CITY OF ALBUQUERQUE

Re: 424/422 Stanford
424/422 Stanford Dr. SE 87106
Traffic Circulation Layout
Engineer's/Architect's Stamp 01-14-2020 (K16D084)

Sheet: Traffic Circulation Layout

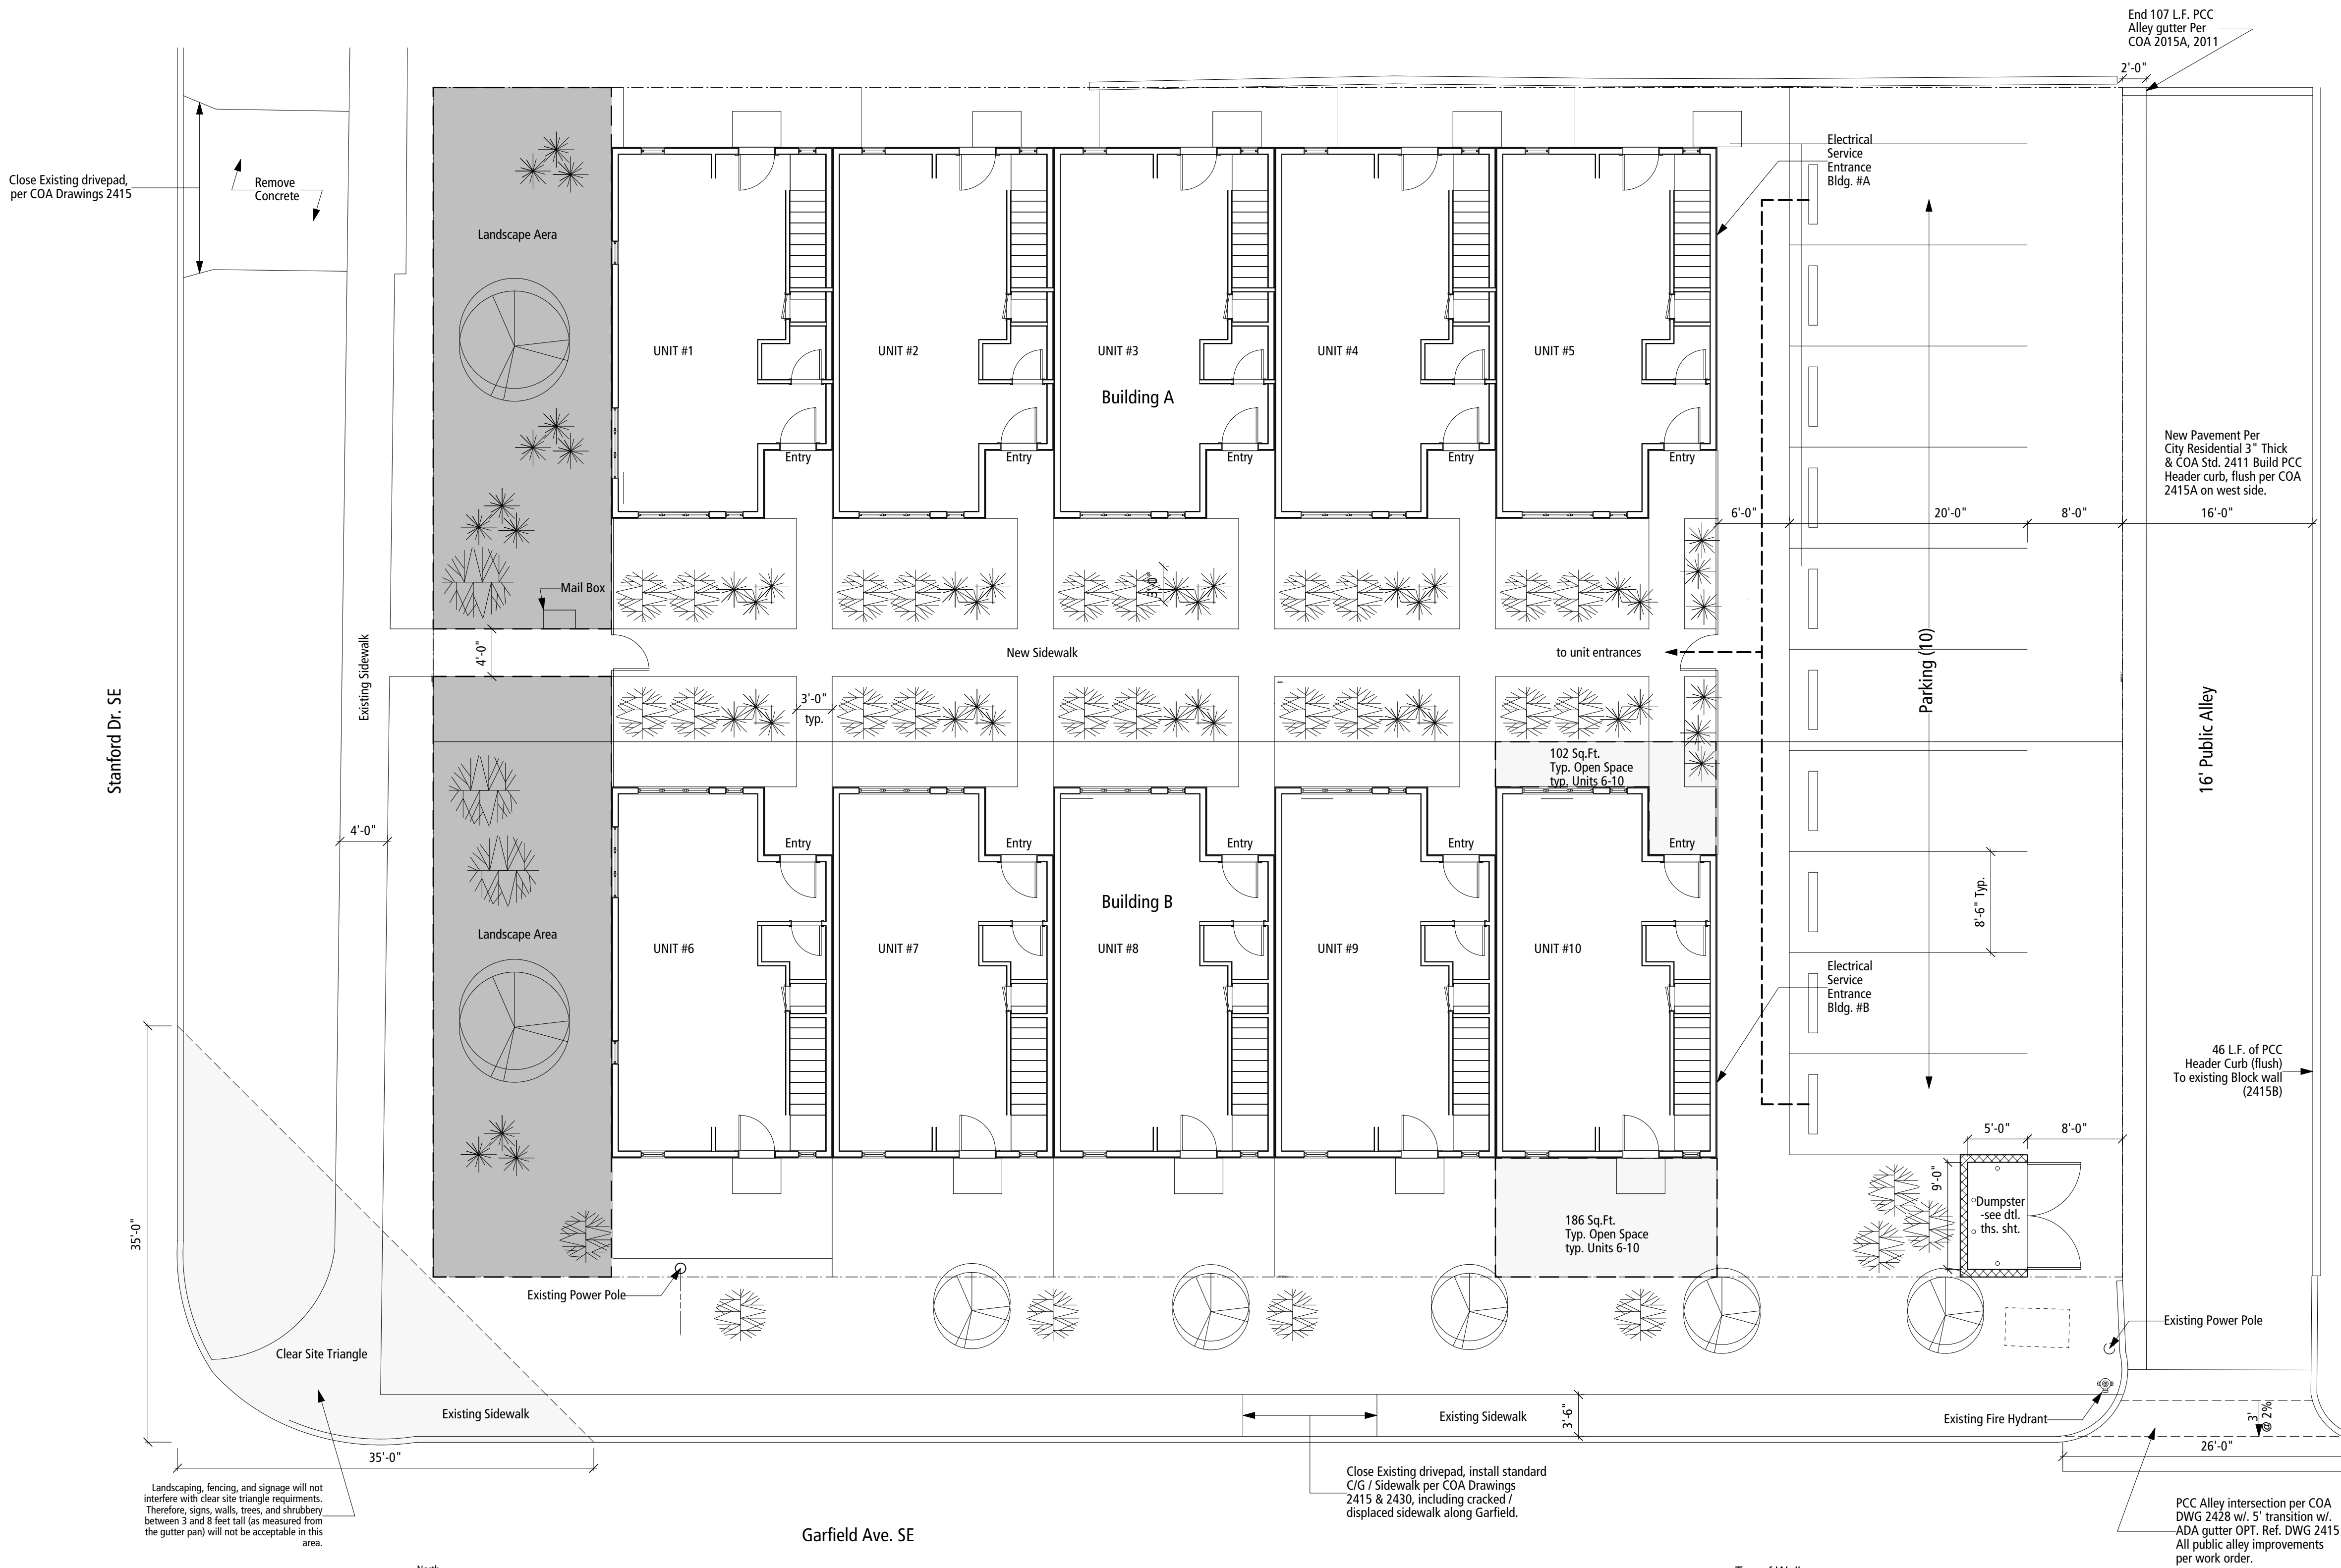
1. A 5 ft. keyway is required for dead-end parking aisles.
2. Refuse vehicle maneuvering shall be contained on-site. The refuse vehicle shall not back into the public right of way.; **provide a copy of refuse approval.**
3. It is not apparent what type of pavement surface is being proposed. A hard driving surface will be required as part of this proposed project for parking area
4. Add a note stating "All broken or cracked sidewalk must be replaced with sidewalk and curb & gutter." A build note must be provided referring to the appropriate City Standard drawing.
